United States Patent and Trademark Office

APPLICATION NO.	FILING DATE	FIRST NAMED INVENTOR	ATTORNEY DOCKET NO.	CONFIRMATION NO
09/684,462	10/06/2000	Mark A. Kottman	087522785134	3279
75	90 02/27/2002			
Russell L. Mcllwain Jones, Day, Reavis & Pogue 77 West Wacker			. EXAMINER	
			HORTON, YVONNE MICHELE	
Chicago, IL 60601-1692			ART UNIT	PAPER NUMBER
			3635	
			DATE MAILED: 02/27/2002

Office Action Summary

DETAILED ACTION

Fig. 10 Fig. 11

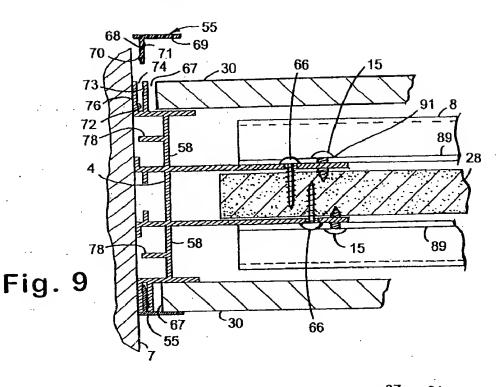
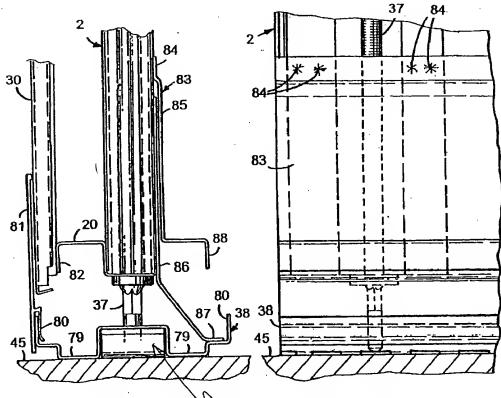
- 5. Claims 4-6 are rejected under 35 U.S.C. 102(b) as being anticipated by US Patent #6,128,877 to GOODMAN et al. GOODMAN et al. discloses the use of a modular wall panel including a generally rectangular frame (2) having a lower channel member (44), a base rail (12), at least two glide assemblies (GA) (see marked-up attachment), apertures (unlabeled), see Figure 18 in the lower channel member for receipt of an upwardly directed threaded member (37). The step of inserting a rotary tool is a method step which is not germane to the issue of patentability of the modular wall panel itself. Therefore, this limitation has not been patentable weight in this apparatus claim.
